**67-69 West 71<sup>st</sup> Street**

Application to amend previously approved storefront design; construct rear yard additions

### Rear yard/façade proposal overview (view above site plans)

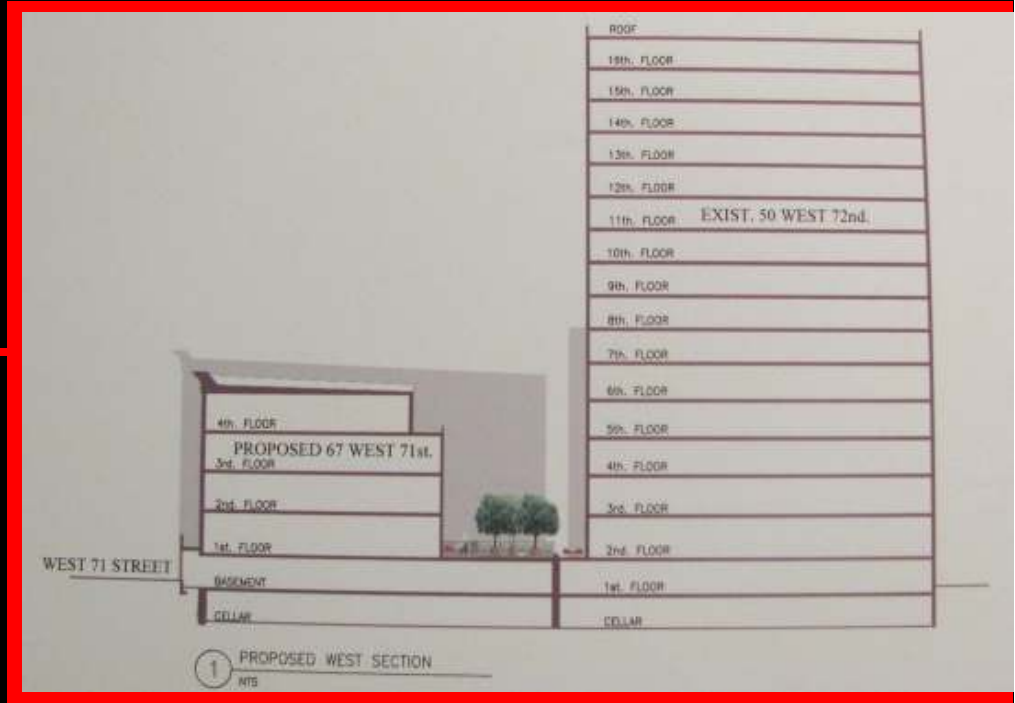
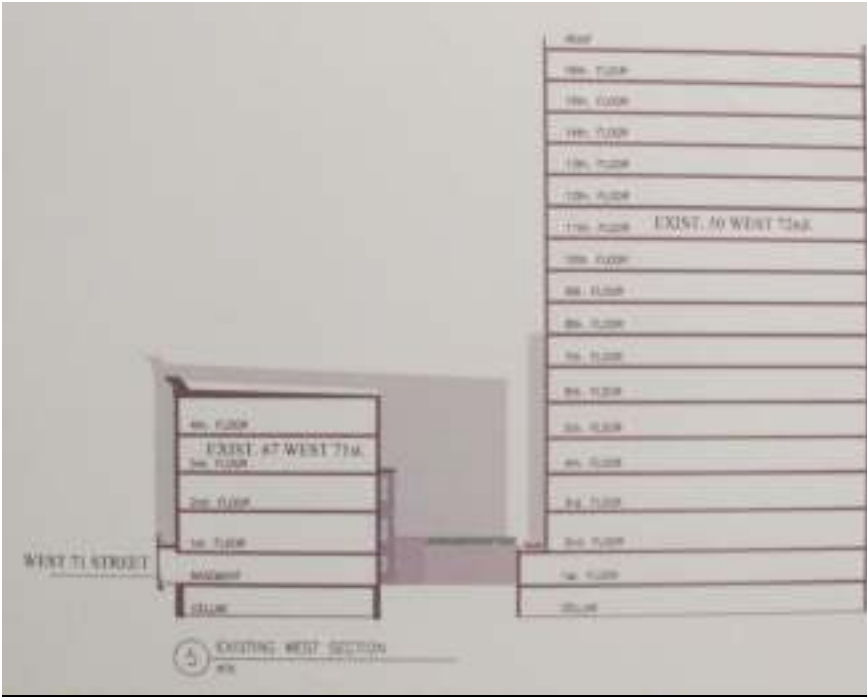
Applicant previously applied to LPC for and received approval for full-width, full-depth rear yard additions at two easternmost properties (indicated as red block in "Previously approved" image).

Applicant now seeking to construct a rear yard addition projecting from the rear facades of those same two buildings, three floors in height (indicated as narrower red block above faded red block in "PROPOSED" image).

### **Proposed rear yard and rear façade**

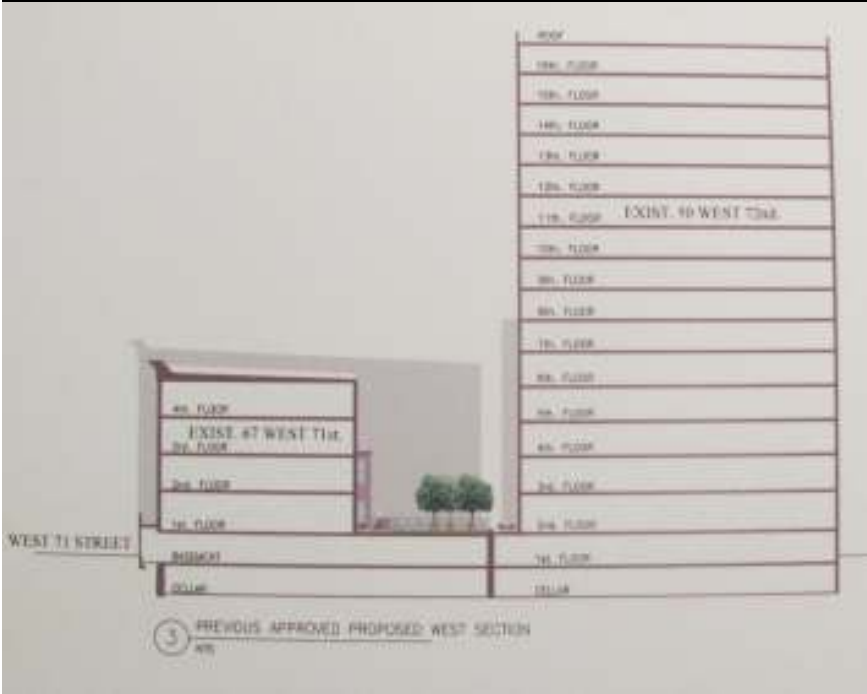
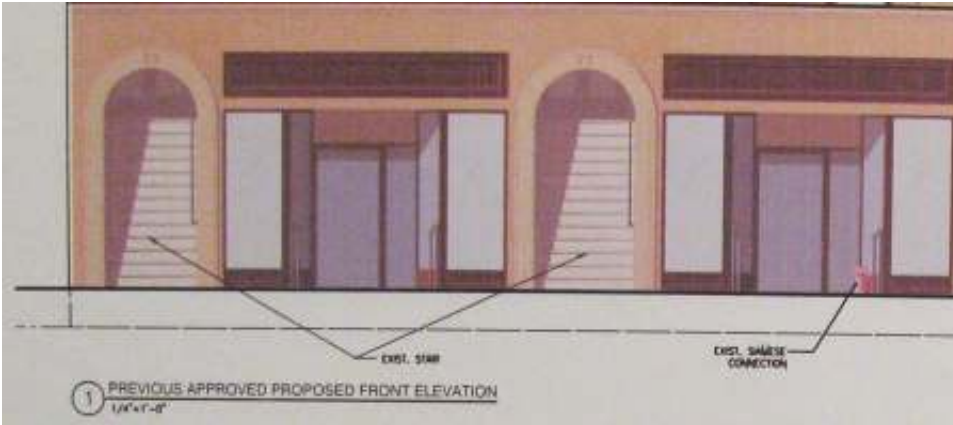
Three story addition extends 8' 7" feet beyond existing rear façade; proposed addition eliminates rear façade bay window (seen at matching building to East); addition provides balcony access for top floor of two row houses; additional landscaping elements added to previously approved rear yard infill's rooftop (more trees, planters, etc.)

**NOTE TO COMMITTEE:** It is not clear (to me) what is being amended. As this architect categorically refuses to acknowledge LW's calls or emails, I'm not able to gain further insight into what modifications should be detected.

Proposed 2008

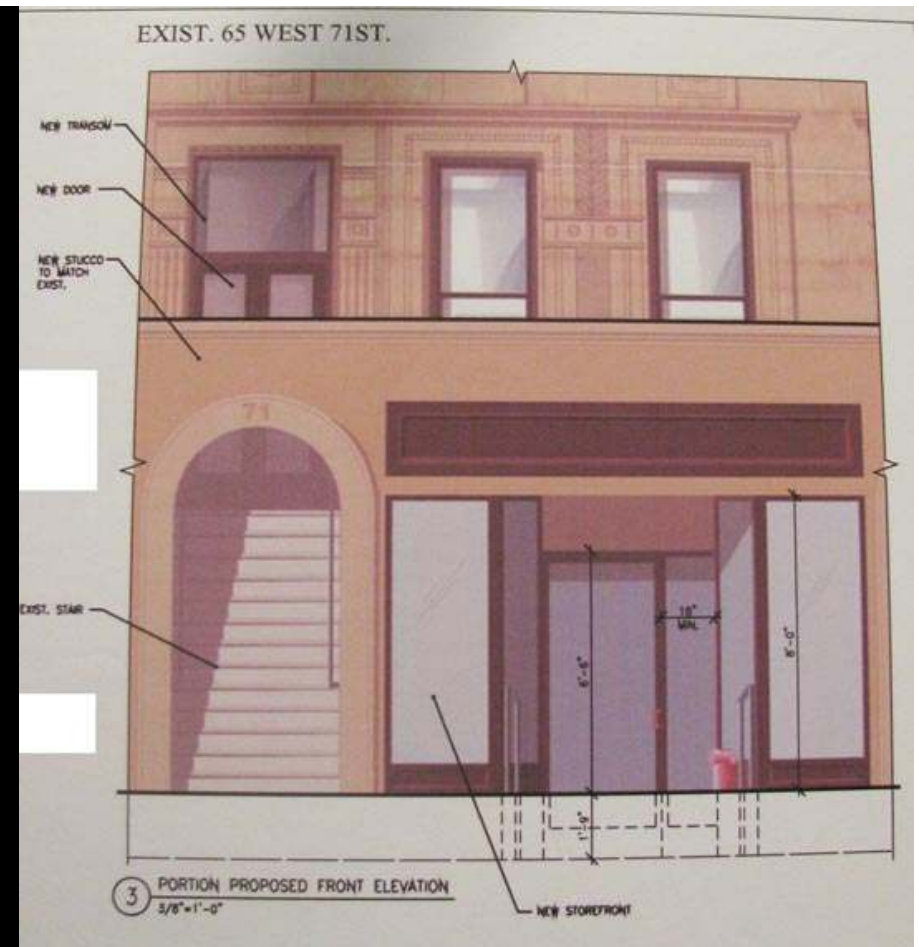
**POINT OF REFERENCE:** The image labeled “Proposed 2008” indicates the storefront previously proposed for this series of buildings. LW! did not approve and Commissioners also noted, at the time, that the repeated storefronts were too monotonous/standard and should reflect a more nuanced ABAB pattern, to mimic the row houses to which they’re attached. No action was taken at the time of public hearing; possible that storefronts were altered at staff level to reflect what is now indicated as “previously approved” on other slides. LW! Will submit Records Access Request and will report findings back to Committee if they arrive pre-hearing (March 27<sup>th</sup>).
